<b>CITY OF WESTMINSTER</b>			
<b>PLANNING APPLICATIONS COMMITTEE</b>	<b>Date</b> 28 July 2015	<b>Classification</b> For General Release	
<b>Report of</b> Director of Planning		<b>Wards involved</b> Hyde Park	
<b>Subject of Report</b>	<b>8 Connaught Square, London, W2 2HG</b>		
<b>Proposal</b>	Use as a single dwellinghouse, excavation of basement floor below lower ground floor of main house and rear extensions, infill extension at lower ground level within rear lightwell, installation of mechanical plant on rear first floor level terrace and associated internal and external alterations.		
<b>Agent</b>	Obsidian London Ltd		
<b>On behalf of</b>	Obsidian London Ltd		
<b>Registered Number</b>	14/11257/FULL 14/11258/LBC	<b>TP / PP No</b>	TP/22363
<b>Date of Application</b>	12.11.2014	<b>Date amended/ completed</b>	10.04.2015
<b>Category of Application</b>	Minor		
<b>Historic Building Grade</b>	Grade II Listed Building

8 CONNAUGHT SQUARE, W2

**DRAFT DECISION LETTER**

PROPOSED FIRST FLOOR

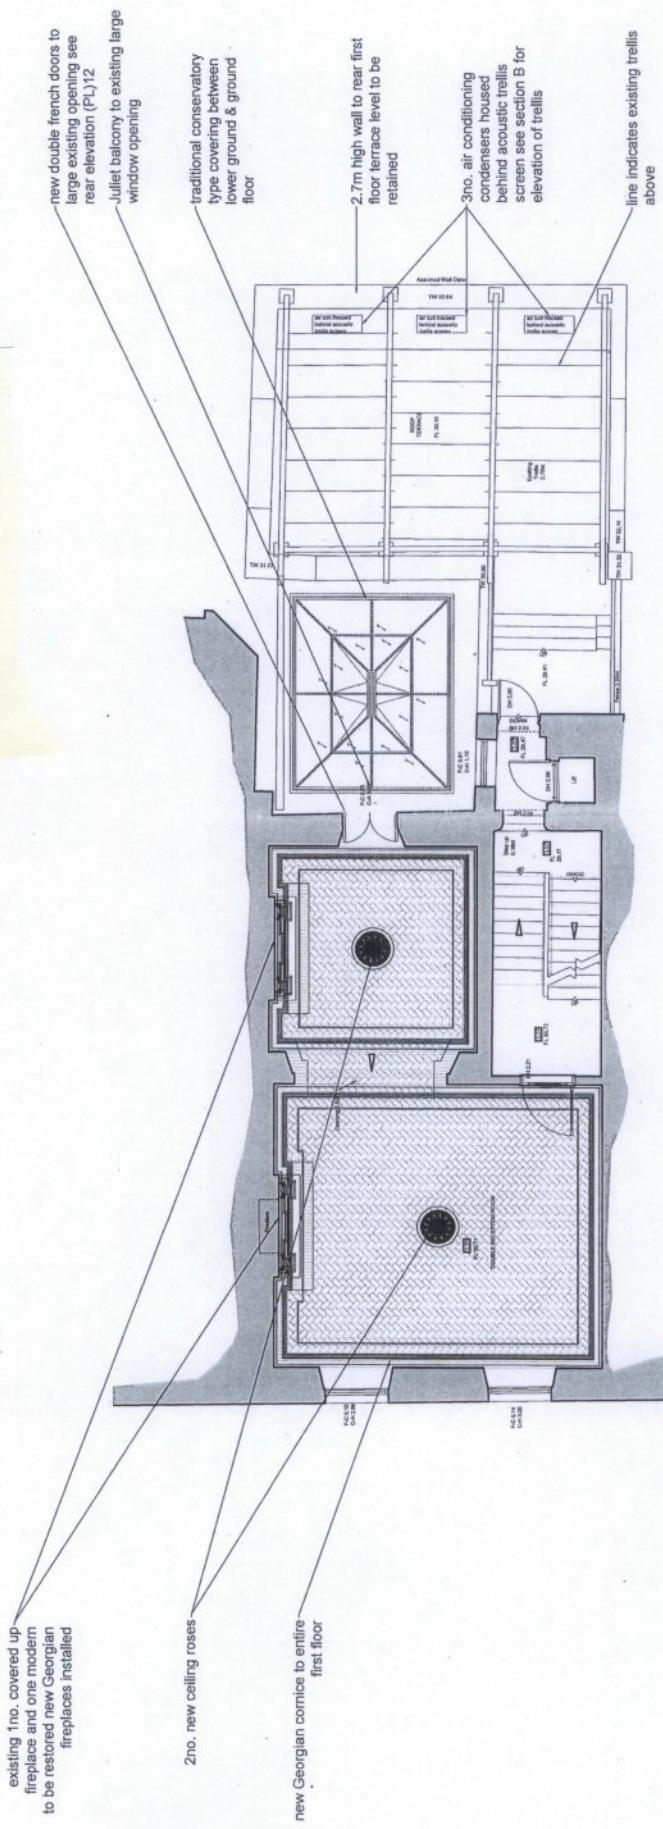
There is a discrepancy in the drawings where they relate to the first floor rear window. On the submitted demolition plan and the proposed elevation no change is shown to the existing situation, whereas on the proposed first floor plan the drawing is drawn and annotated such that it indicates the removal of the window and introduction of French doors and (presumably, although one is not shown) a balcony. The loss of this window is considered to be harmful to the character and appearance of the listed building and the Bayswater Conservation Area. It is recommended that the planning permission and listed building consent are refused on this ground.

1st floor  
to be inserted?

- Reason:
- 1 Because of the loss of fabric and change in design and appearance, the introduction of French doors and balcony to the rear at first floor level would harm the special interest (significance) of this grade II listed building. It would also fail to maintain or improve (preserve or enhance) the character and appearance of the Bayswater Conservation Area. This would not meet S25 and S28 of Westminster's City Plan: Strategic Policies that we adopted November 2013 and DES 1, DES 5, DES 9 and DES 10 of our Unitary Development Plan that we adopted in January 2007.
